LANDMARKS BOARD

RE: Landmarks Board meeting

STAFF REPORT

STAFF REPORT

Lighted Wall Cabinet Install Section Detail

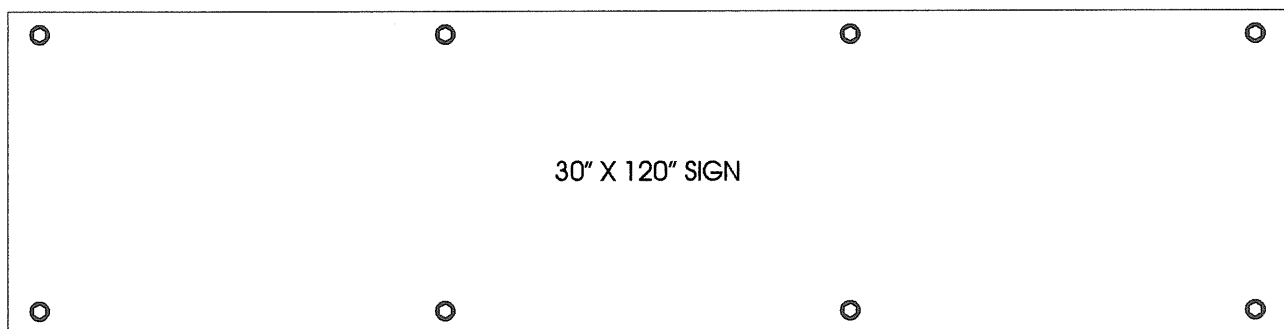
1. The proposed signs are considered removable features.
2. National Park Service Guidelines recommend the fittings should penetrate mortar joints, rather than brick.
3. Commercial Street Design Guidelines recommend the content of signs shall be limited to the business name.

3. After review of Preservation Brief #25 and the building, staff believes that the internally lit sign does not overpower the historic structure or surrounding buildings and that the content of the sign is appropriate. Staff would recommend that any attachments to the building made through the mortar joints and not the brick as recommended by the National Parks Service.

1. Install a temporary flat sign board with dimensions and business information as shown on attached drawing. The sign shall be attached through the mortar joints and not the brick. No lighting of the sign was permitted.

PROPOSED FLOOR PLANS

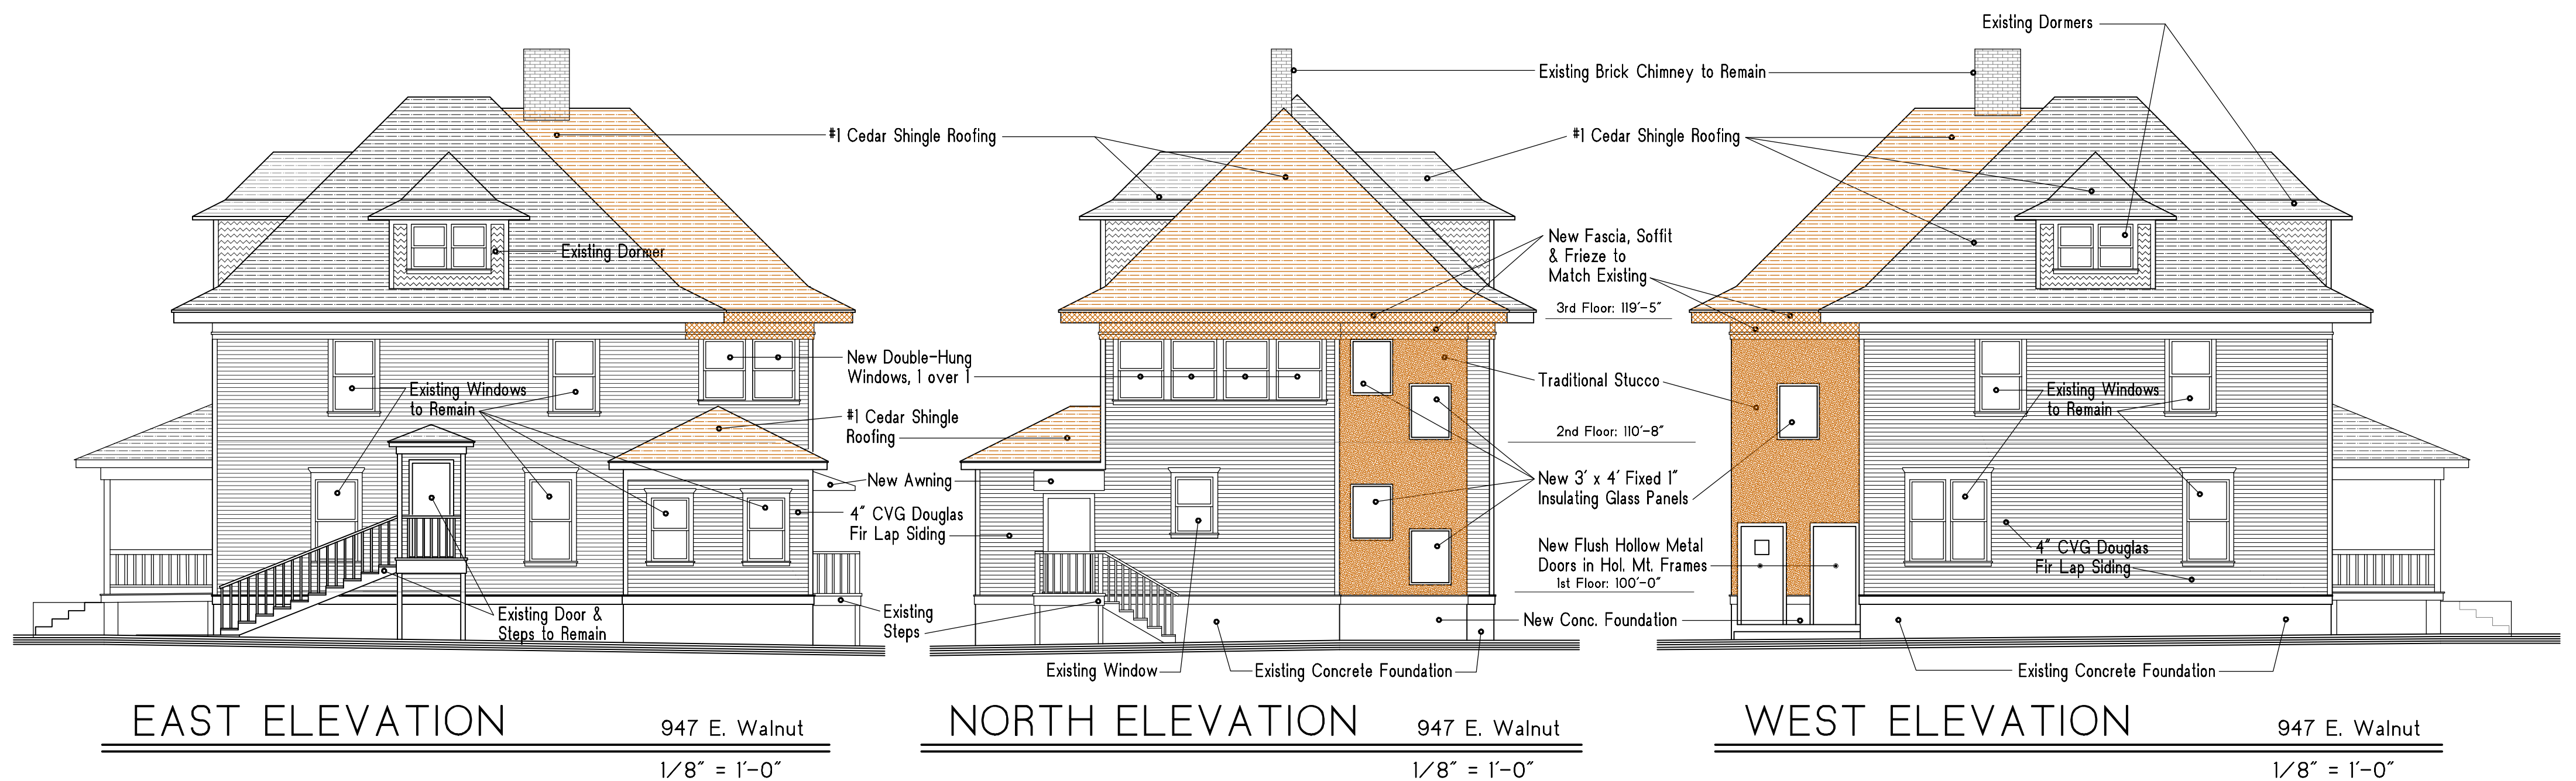
1. The proposed addition follows the Walnut Street Design Guidelines by being placed on the rear elevation, not overpowering the historic structure and not creating any false historic appearances. While the roofline on the existing rear addition will be modified, staff does not see this interfering with the overall appearance of the structure especially since the new addition will be in the back. The new materials proposed should differentiate the historic from the new.

2. While the Walnut Street Design Guidelines do not specifically prohibit aluminum framed windows, the Secretary of Interior's Standards recommend materials that can be found within the same period in which the structure was built or a prominent era. The proposed doors have the same issue.
